MEDICAL CENTER OF AURORA SOUTH
AURORA, COLORADO

MEDICAL OFFICE BUILDING

AURORA BUILDING INSPECTION
ELECTRICAL SECTION
APPROVED
SUBJECT TO COMMENTS AS NOTED
AND FIELD INSPECTIONS

CITY OF AURORA
ELEC. SECTION
Approved as Noted
Date DEC 16 2004
With Attachment

FIRST FLOOR ELECTRICAL PLAN

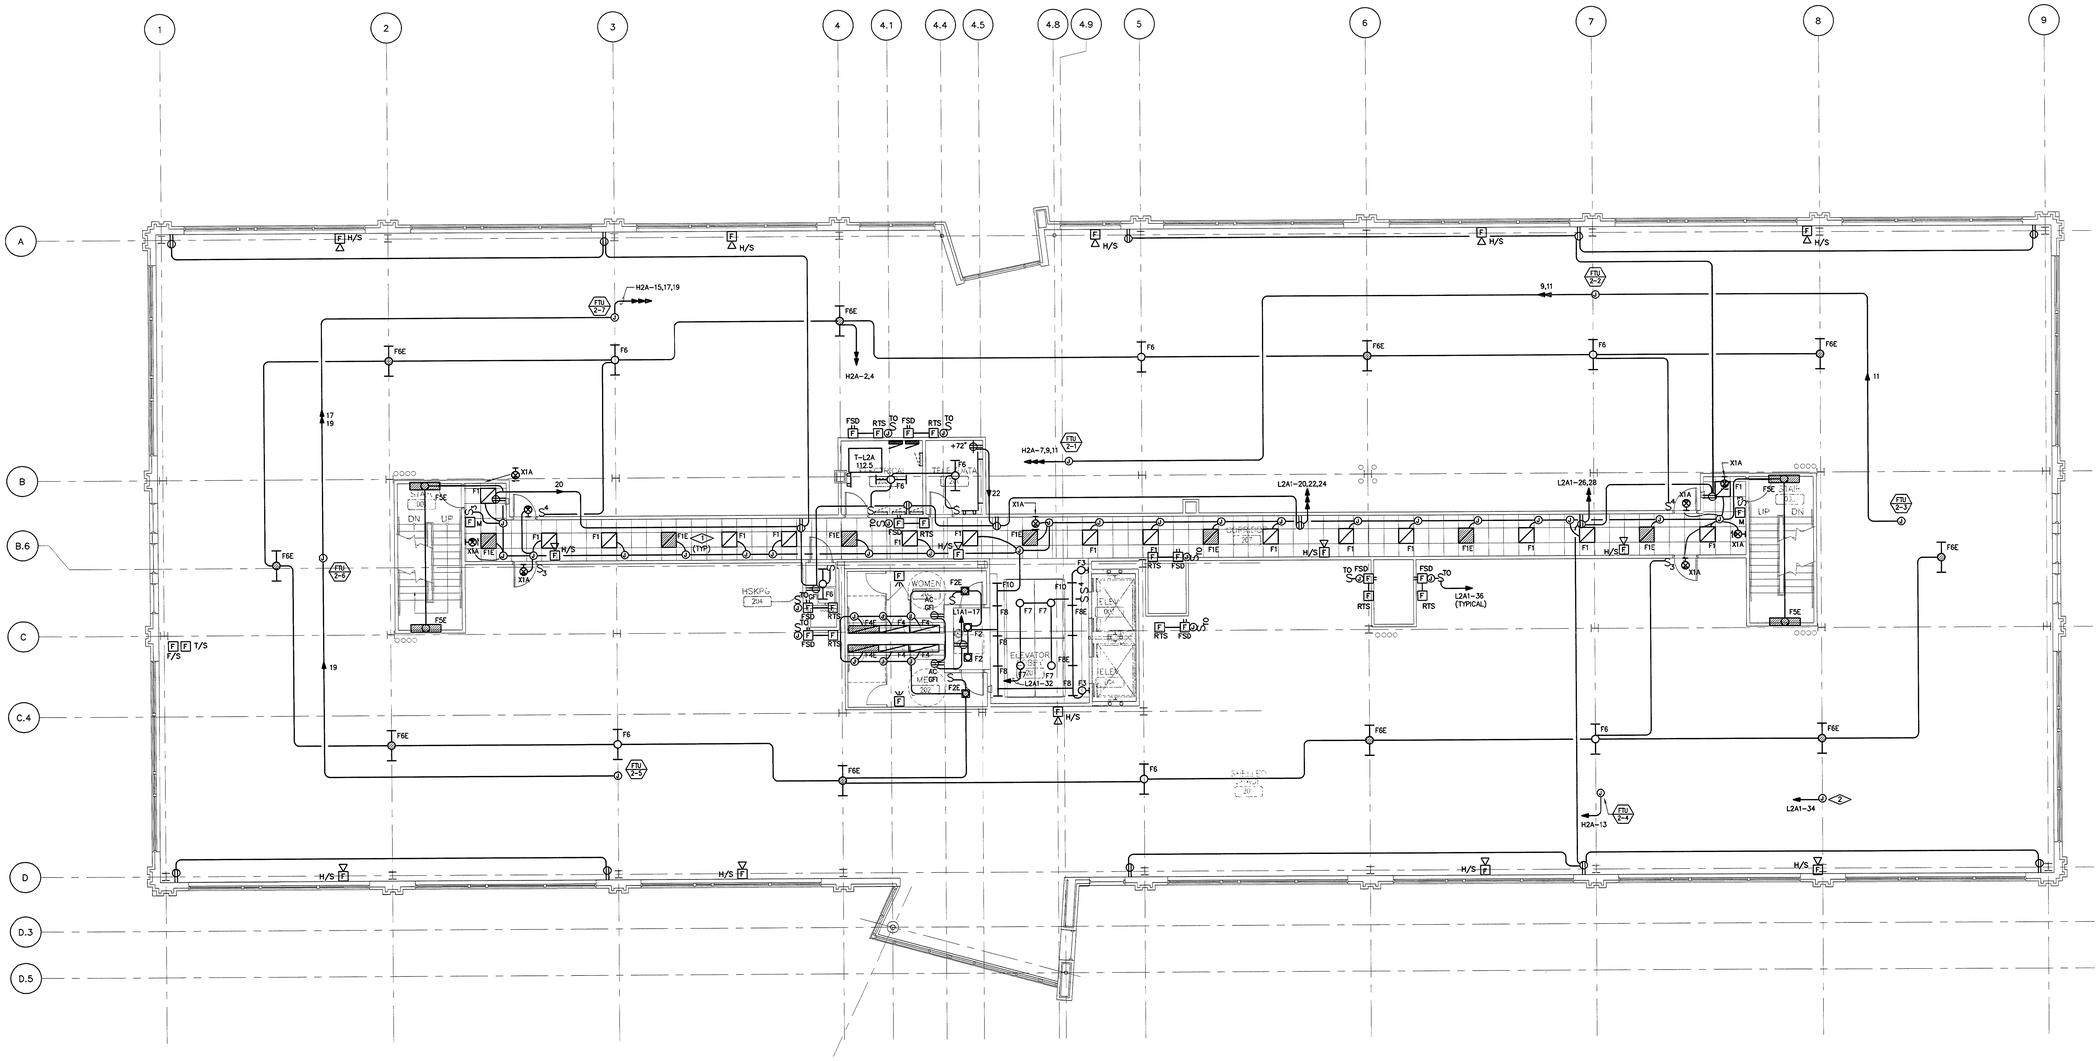
Overcurrent protection shall be located in the machine room. NEC 620.22
